RE: PR-2024-009765 SI 2023-00468 – Site Plan- EPC

### SI-2023-00468 – Site Plan EPC, Major Amendment

**RE: PR-2024-009765, SI-2024-00468  
SITE PLAN – EPC MAJOR AMENDMENT  
RESPONSE TO CONDITIONS OF APPROVAL  
TRACT A PLAT OF GATEWAY SUBDIVISION CONT 2.7845 AC  
IDO ZONE ATLAS PAGE J-15-Z**

Project # PR-2024-009765  
SI-2023-00468 – Site Plan – EPC, Major Amendment

1 ENLARGED SITE PLAN - LOADING DOCK  
3/16" = 1'-0"

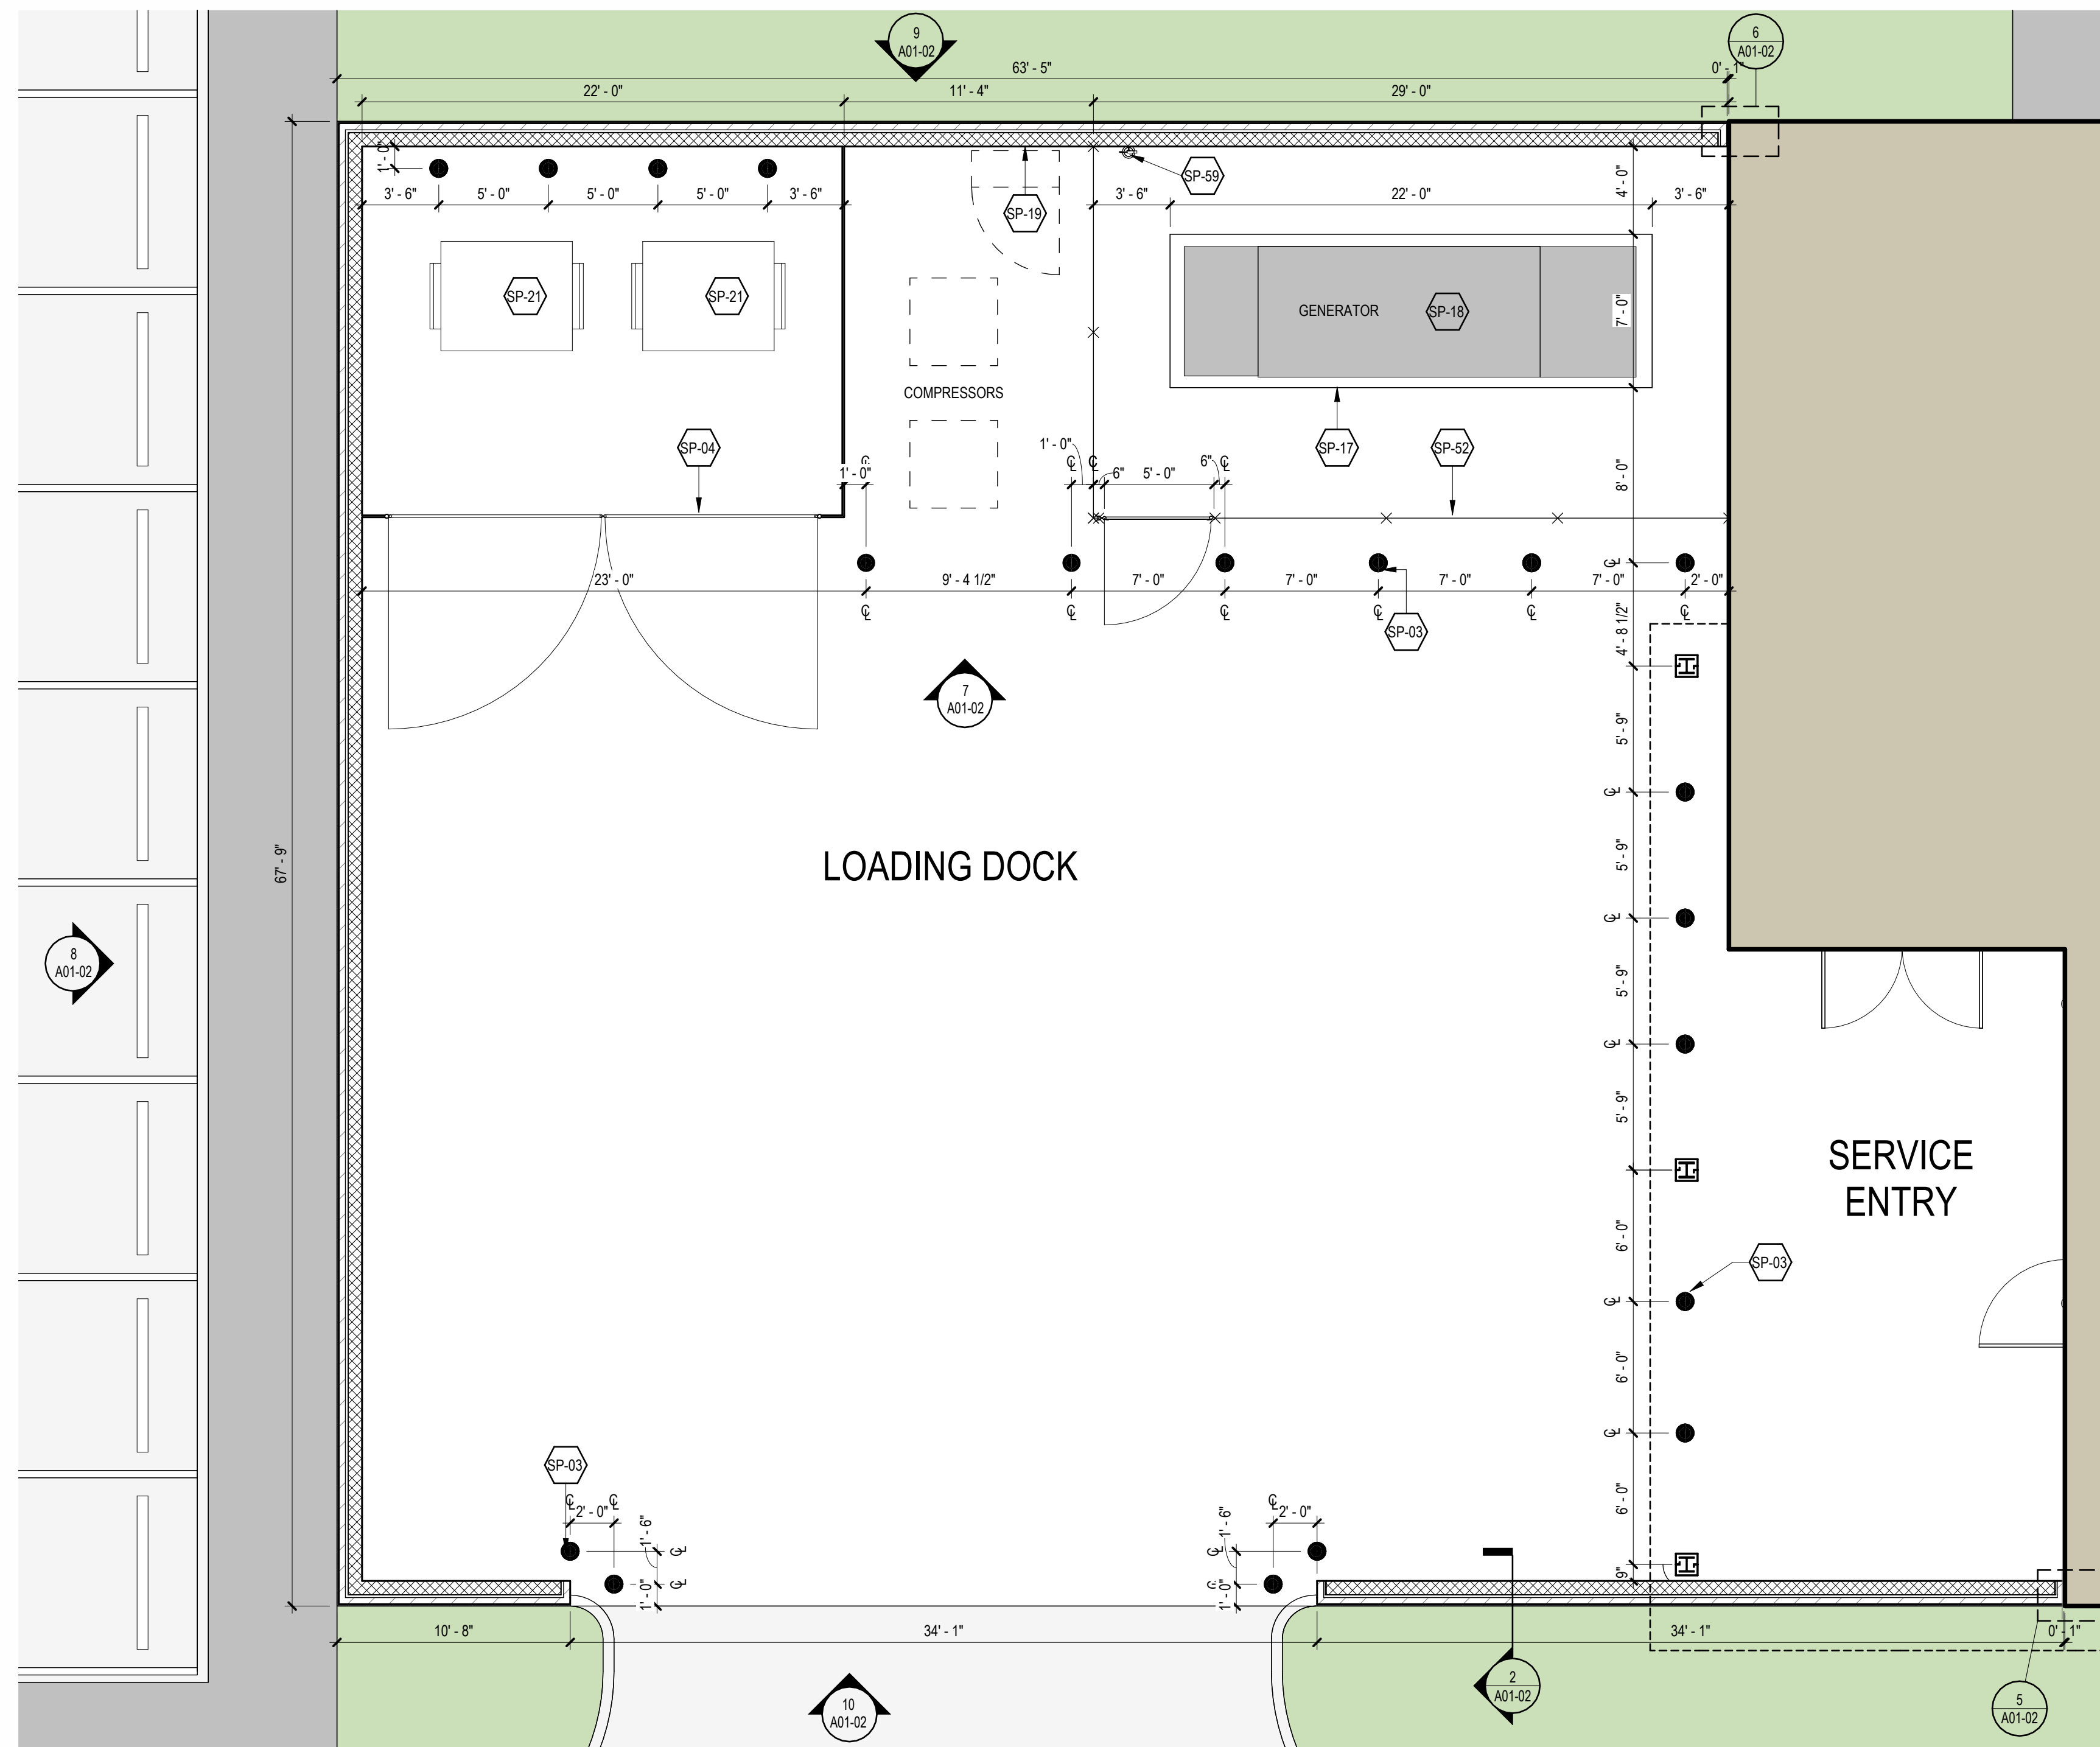
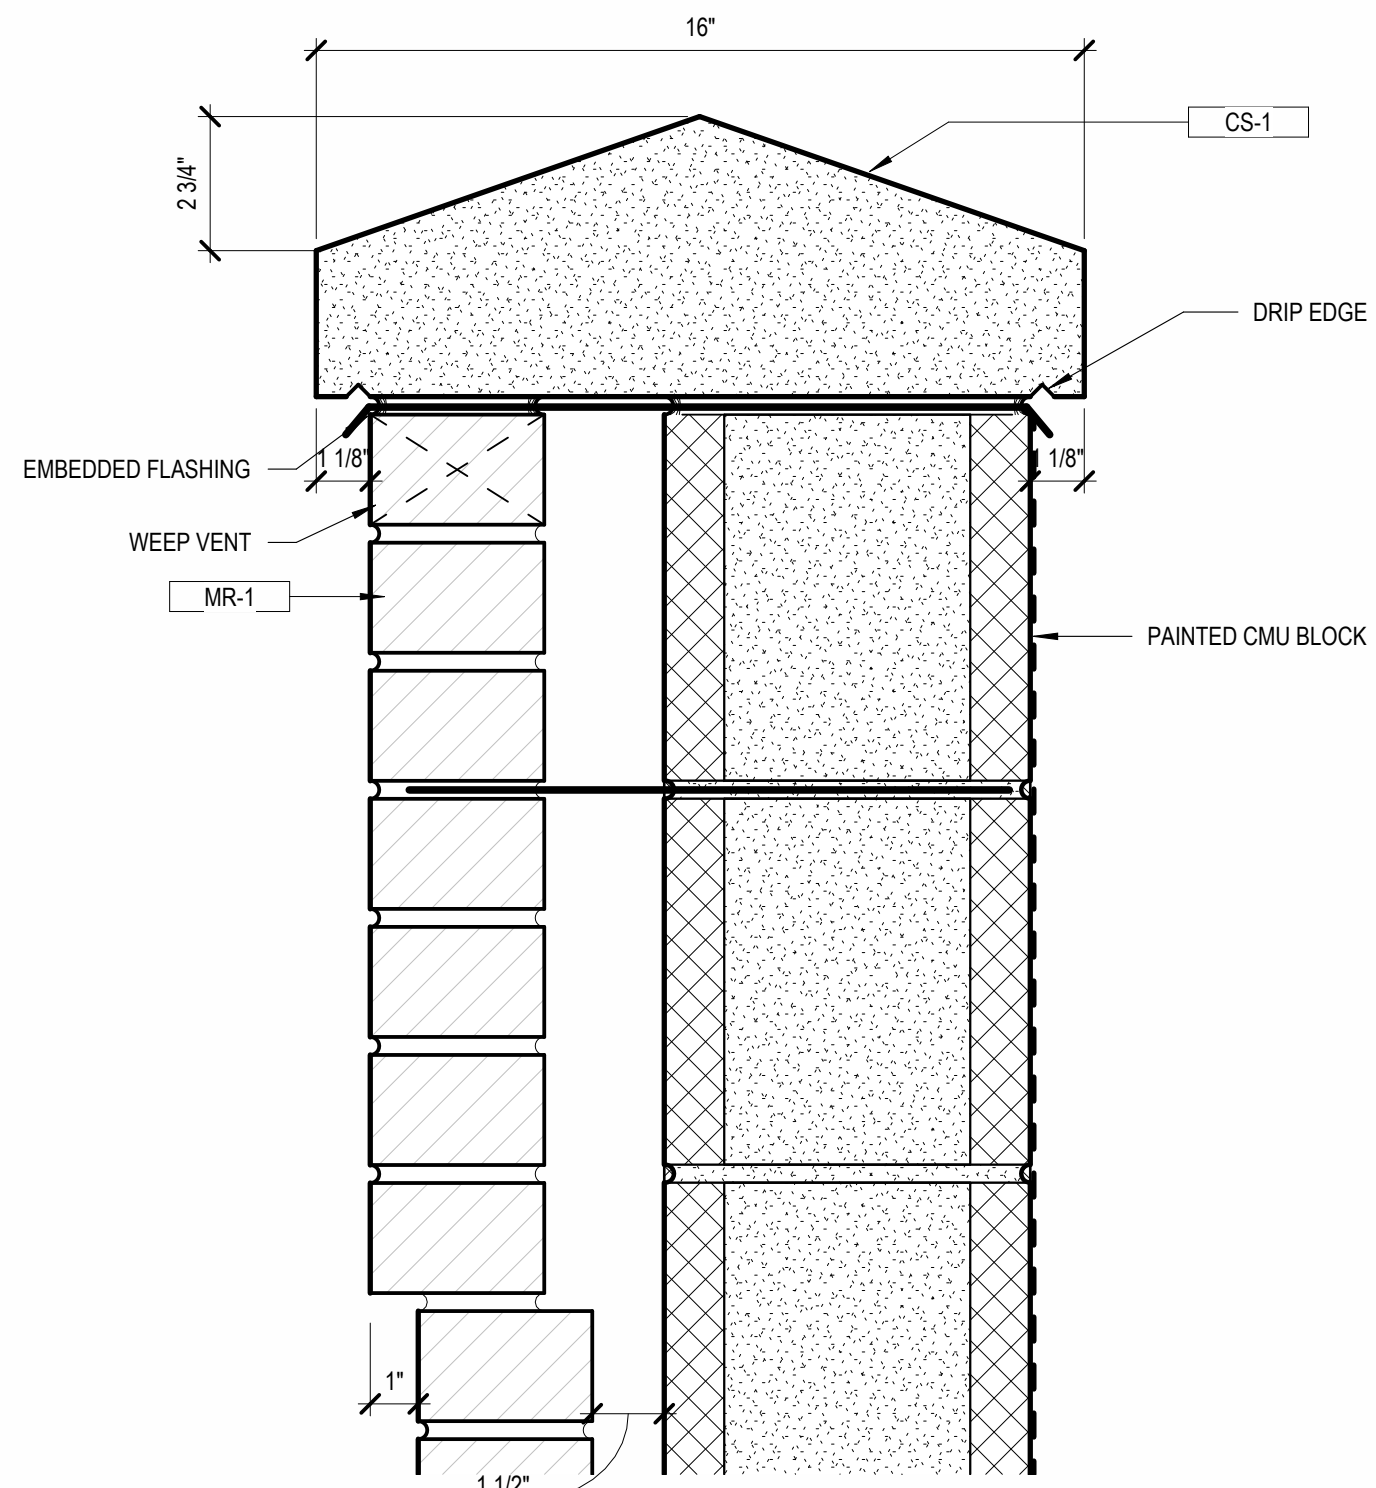
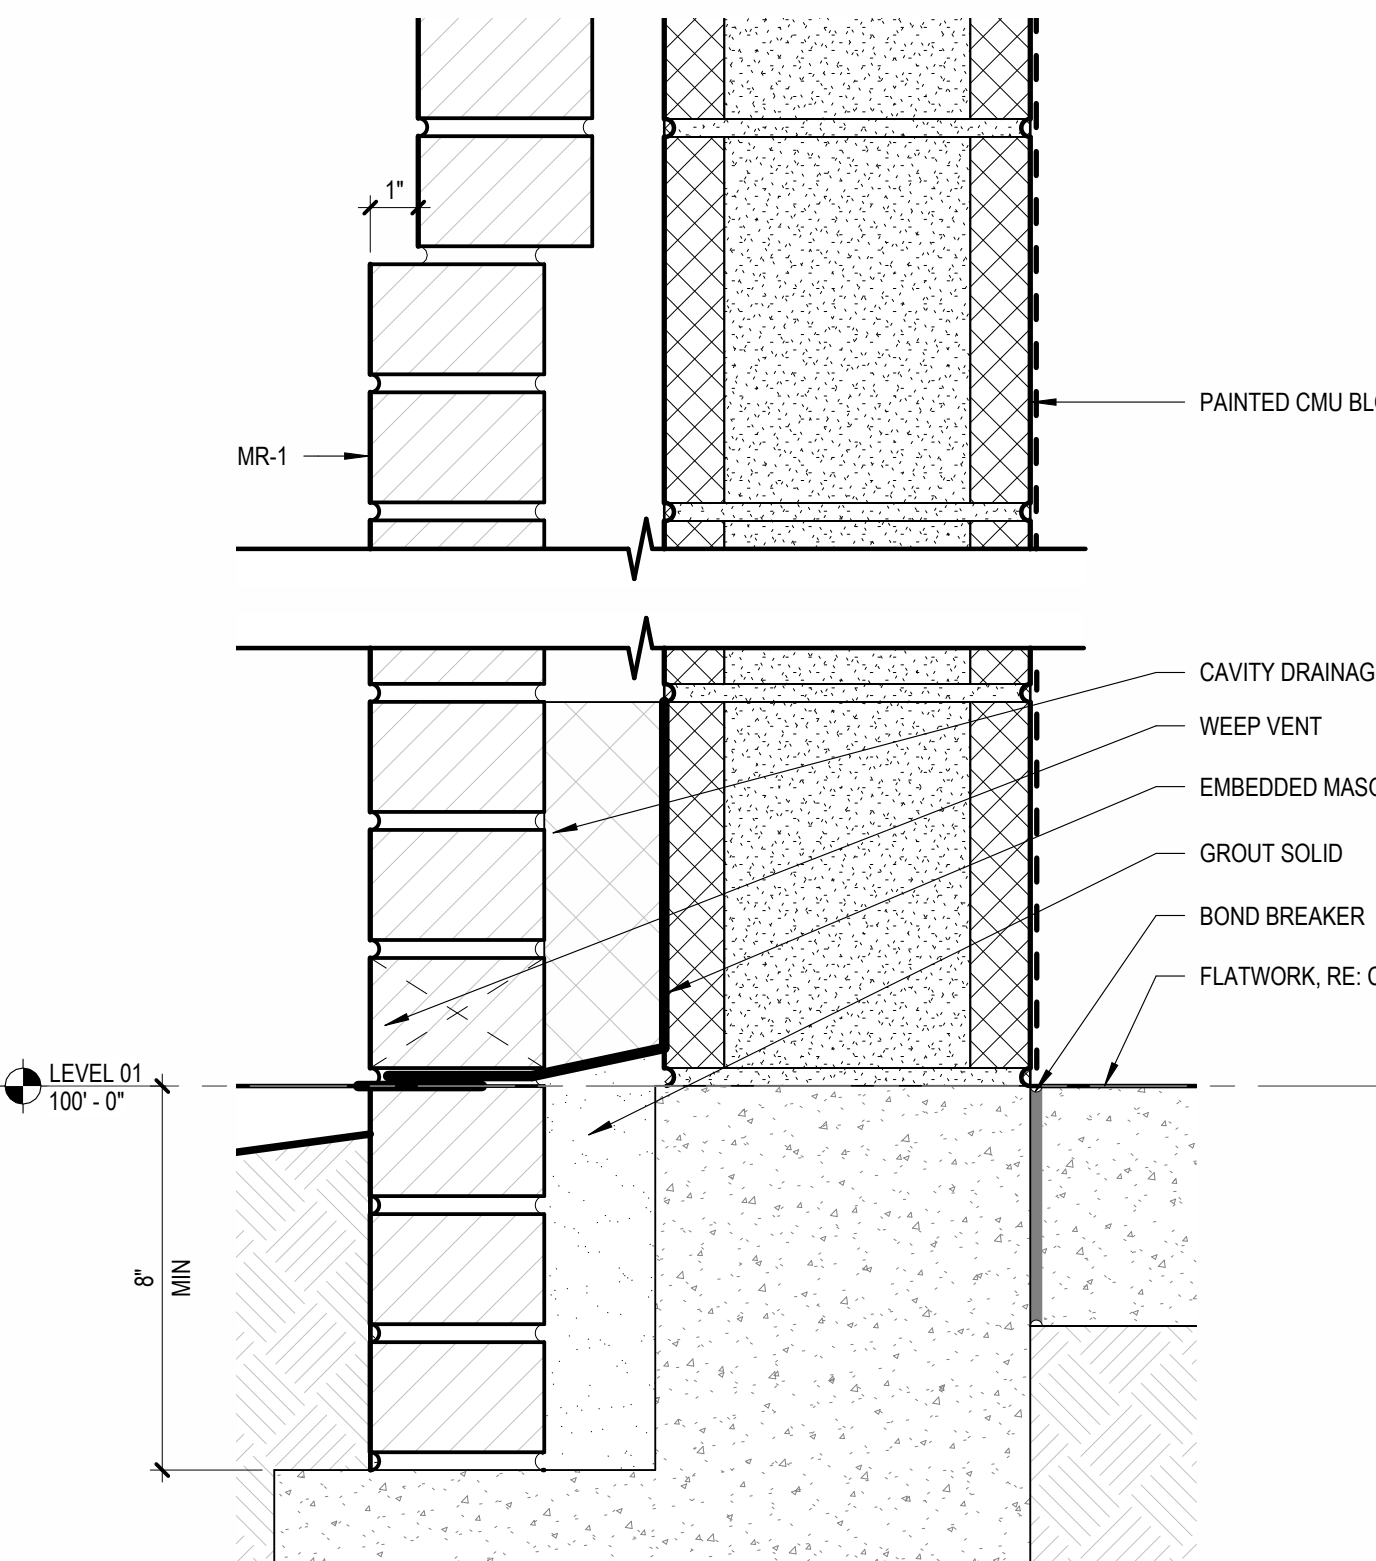
- A. The applicant shall provide a detailed drawing for the generator.  
***We have provided the specifications for the generator and a detail drawing for the enclosure area on sheet A01-02***

- B. A detail of the attached wall to enclose the dumpster and generator area on the western side of the building shall be provided.  
***This has been provided on A01-02***
